# UNITED STATES PATENT AND TRADEMARK OFFICE

APPLICATION NO.	FILING DATE	FIRST NAMED INVENTOR	ATTORNEY DOCKET NO.	CONFIRMATION NO.
10/823,355	04/12/2004	Robert Martinson	NOVE100042000/NVLS-2898	4719
83586	7590	02/18/2010	EXAMINER	
Delio & Peterson, LLC 121 Whitney Avenue New Haven, CT 06510			BAND, MICHAEL A	
			ART UNIT	PAPER NUMBER
			1795	
			MAIL DATE	DELIVERY MODE
			02/18/2010	PAPER

**Office Action Summary****Application No.**

## DETAILED ACTION

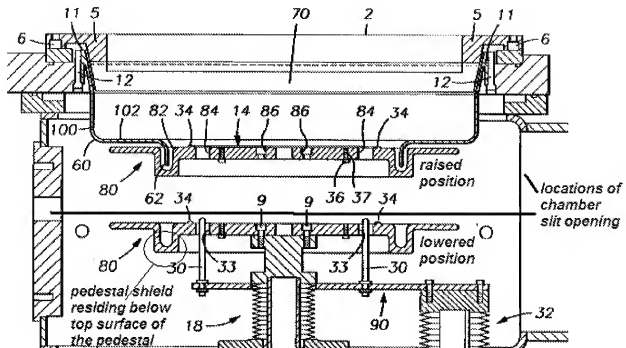
With respect to claims 21-24, the references are cited as discussed for claim 1. Chung et al further teaches in figs. 6A-6B the pedestal shield [84] removably attached to an end portion of the pedestal [82] via a mechanical connection [92] (col. 6, lines 51-64). The cropped figure below of fig. 6A serves to further clarify the pedestal end portion.

However Chung et al is limited in that it is not suggested for the end portion of the pedestal to be a separate isolated ring.

Ref 2 teaches a removable deposition shield assembly [550] for a sputtering chamber, where said deposition shield assembly [550] comprises a removable shield ring [20] resting and secured directly on a removable deposition (i.e. pedestal isolator) ring [522] where said deposition ring [522] is attached to a pedestal [504] (abstract; fig. 6). Ref 2 further teaches that "in essence, the deposition ring [522] is a removable extension [i.e. end portion] of [a] support surface of the pedestal [504]" (col. 6, lines 8-9). Ref 2 cites the advantage of using the deposition ring as preventing deposition on the chamber and hardware outside the processing region and facilitating replacement of the deposition ring due to built-up deposition material (abstract; col. 7, lines 28-35).

It would have been obvious to one of ordinary skill in the art to use the deposition ring as taught by Ref 2 in place of the end portion of the pedestal of Chung et al to gain the advantages of preventing deposition on the chamber and hardware outside the processing region and facilitating replacement of the deposition ring due to built-up deposition material. In addition since both Chung et al and Ref 2 teach end portions of a pedestal to prevent deposition particles from reach the bottom of the deposition

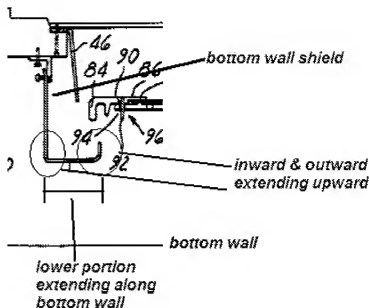
7. On p. 14-15, the Applicant argues that Chung et al does not teach the pedestal shield and sidewall cooperating when the pedestal is in the raised deposition position. The Applicant also argues that Chung et al does not teach a bottom wall shield having a lower portion extending along a bottom wall with inward and outward portions extending upward from said bottom wall lower portion.

The Examiner respectfully disagrees since the secondary reference Chung et al was not used to teach this cooperation; Tepman et al (i.e. Ref 1) explicitly and clearly teaches in fig. 5 the pedestal [80] in the raised position with the pedestal shield [82] cooperating with the sidewall shield [60]. In addition in response to Applicant's arguments against the references individually, one cannot show nonobviousness by attacking references individually where the rejections are based on combinations of references. See *In re Keller*, 642 F.2d 413, 208 USPQ 871 (CCPA 1981); *In re Merck & Co.*, 800 F.2d 1091, 231 USPQ 375 (Fed. Cir. 1986). The Examiner also would be remiss in not pointing out that Chung et al also does depict in fig. 8 all three shields [46], [48], [84] cooperating when the pedestal [82] is in the raised position to prevent deposition from reaching the bottom wall (i.e. floor), with fig. 6B depicting the bottom wall shield having the claim limitations. The cropped figure below of fig. 6B serves to further clarify these claim limitations.
